STATE OF UTAH
DEPARTMENT OF NATURAL RESOURCES
DIVISION OF OIL, GAS AND MINING

APPLICATION FOR PERMIT TO DRILL		5. MINERAL LEASE NO: ML-46532	6. SURFACE: State
1A. TYPE OF WORK: DRILL <input checked="" type="checkbox"/> REENTER <input type="checkbox"/> DEEPEN <input type="checkbox"/>		7. IF INDIAN, ALLOTTEE OR TRIBE NAME:

2. NAME OF OPERATOR: KERR MCGEE OIL & GAS ONSHORE L.P.		9. WELL NAME and NUMBER: LOVE 1121-16C	
3. ADDRESS OF OPERATOR: 1368 S 1200 E CITY VERNAL STATE UT ZIP 84078		PHONE NUMBER: (435) 781-7024	10. FIELD AND POOL, OR WILDCAT: UNDESIGNATED Love 622

**WORKSHEET
APPLICATION FOR PERMIT TO DRILL**

TOPOGRAPHIC MAP 12 22 06
MONTH DAY YEAR
SCALE: 1" = 2000' DRAWN BY: C.P. REVISED: 00-00-00

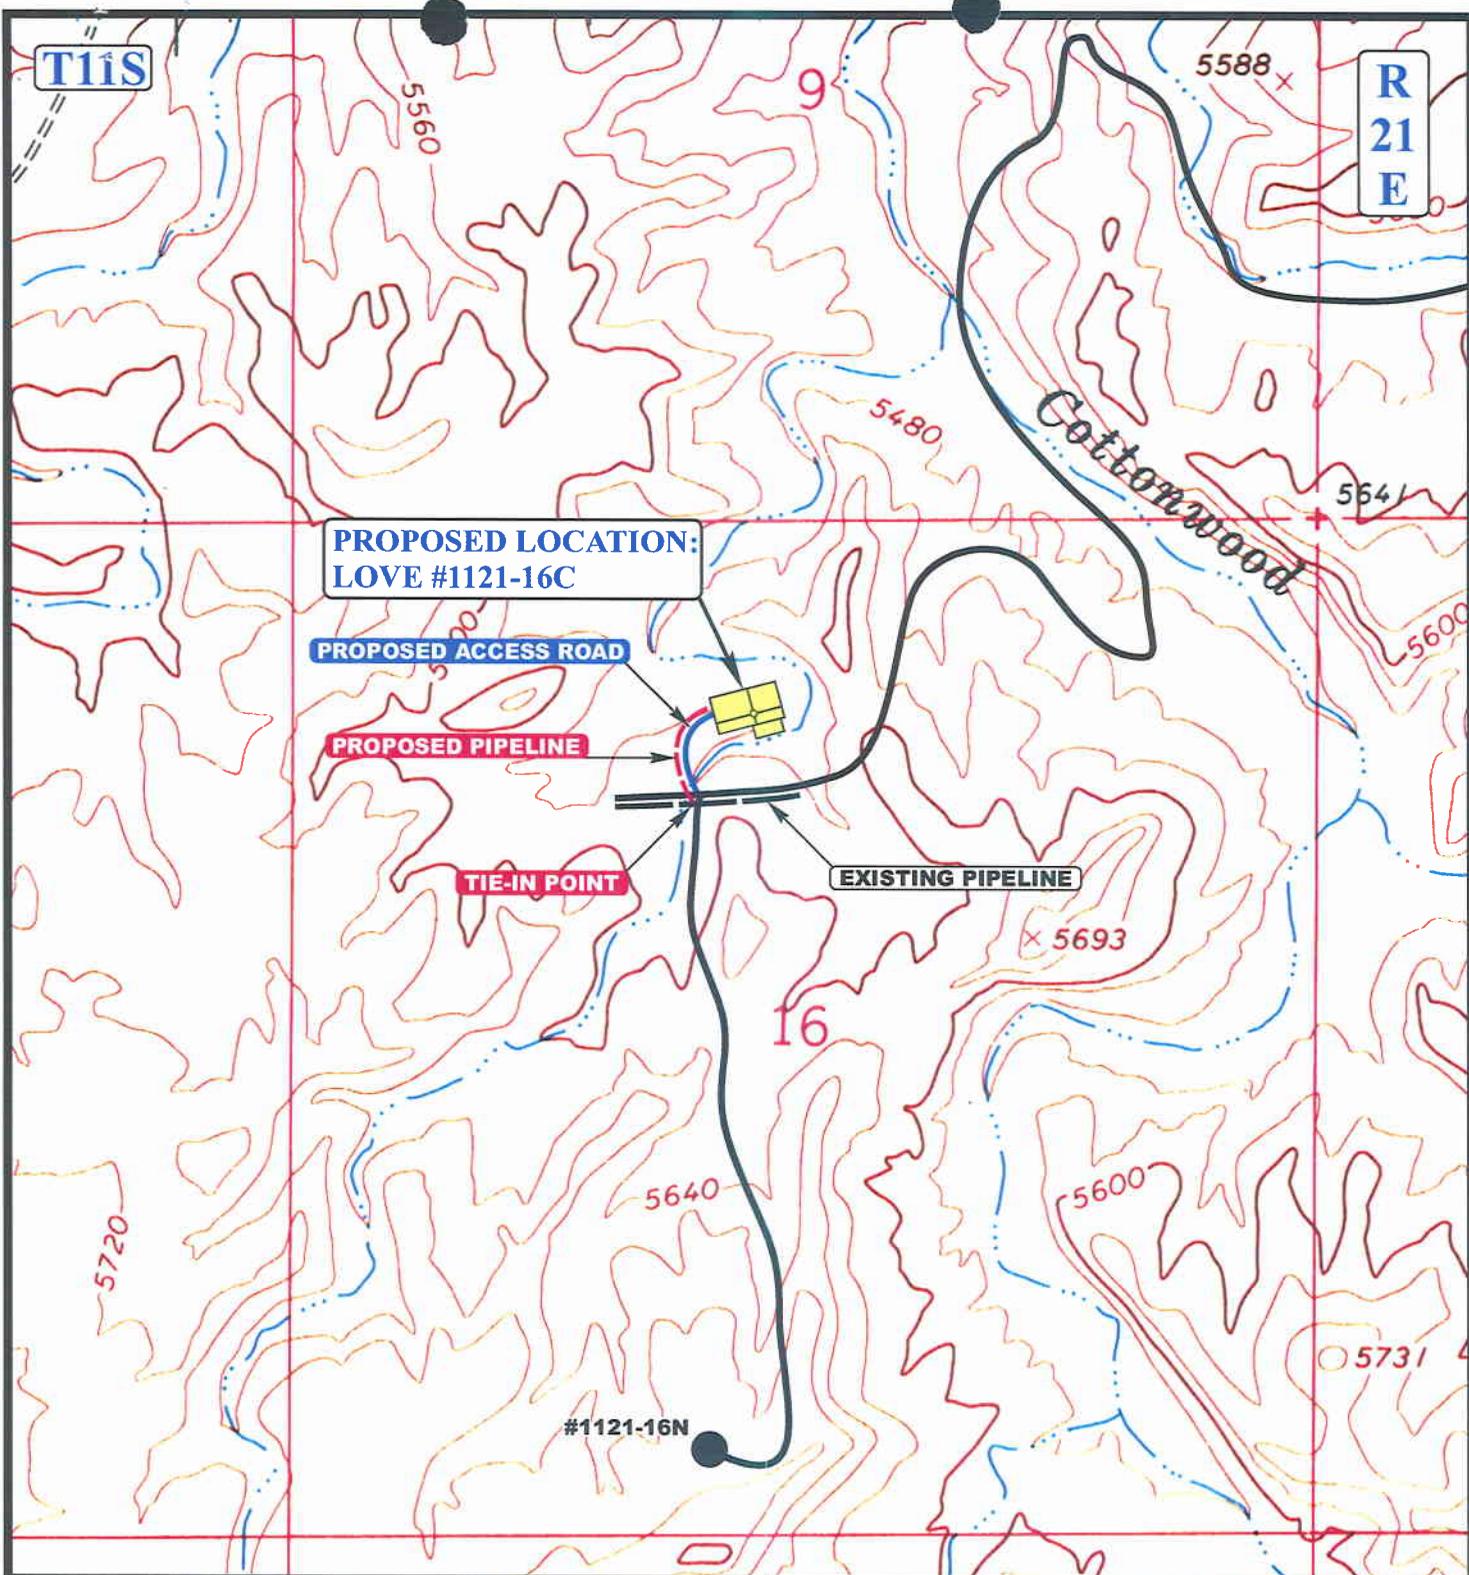
An onsite was conducted on 4/4/07 with the Division of Oil, Gas and Mining Representative and SITLA Representative. It was decided to change the proposed pipeline from a 4" pipeline that was approximately 547' +/- to, a 4" pipeline approximately 547' +/- and an 8" pipeline approximately 3,750' +/-.
